BURNETT RIVER FLOODPLAIN ACTION PLAN

COMMUNITY REFERENCE GROUP MEETING

TUESDAY 31 OCTOBER 2013 – 4PM

AGENDA

North Levees

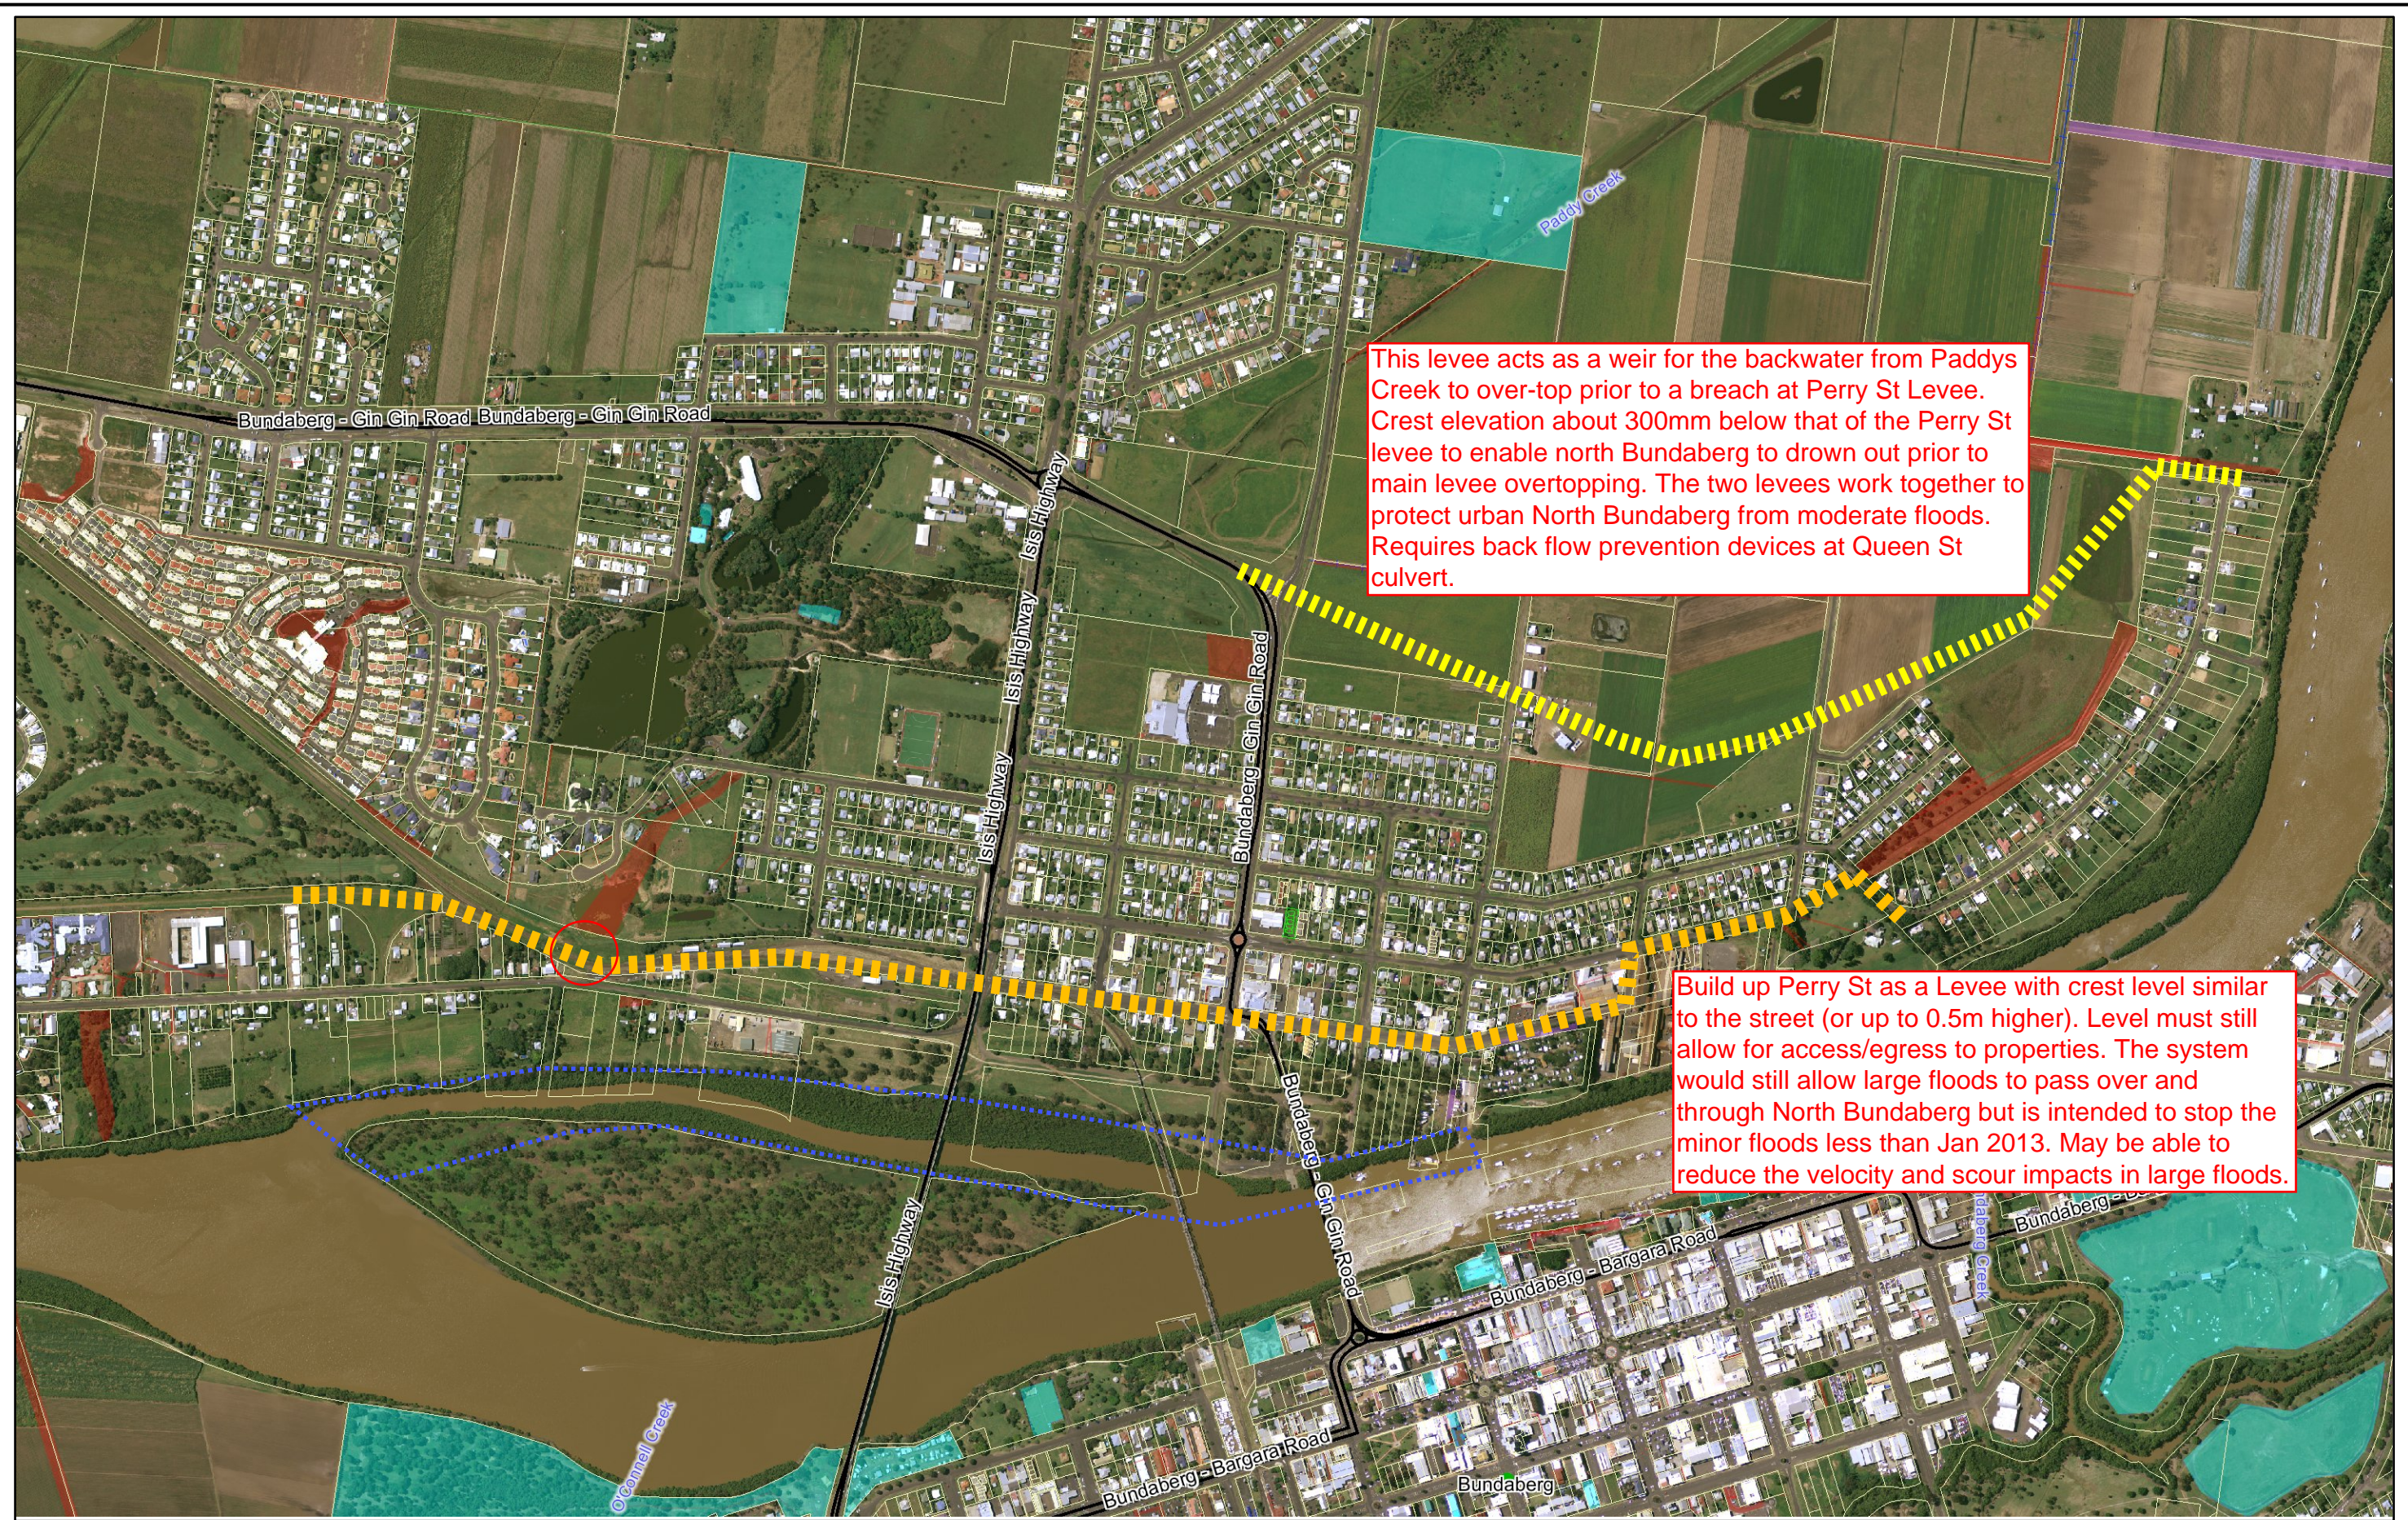
This levee acts as a weir for the backwater from Paddys Creek to over-top prior to a breach at Perry St Levee. Crest elevation about 300mm below that of the Perry St levee to enable north Bundaberg to drain out prior to main levee overtopping. The two levees work together to protect urban North Bundaberg from moderate floods. Requires back flow prevention devices at Queen St culvert.

Build up Perry St as a Levee with crest level similar to the street (or up to 0.5m higher). Level must still allow for access/egress to properties. The system would still allow large floods to pass over and through North Bundaberg but is intended to stop the minor floods less than Jan 2013. May be able to reduce the velocity and scour impacts in large floods.
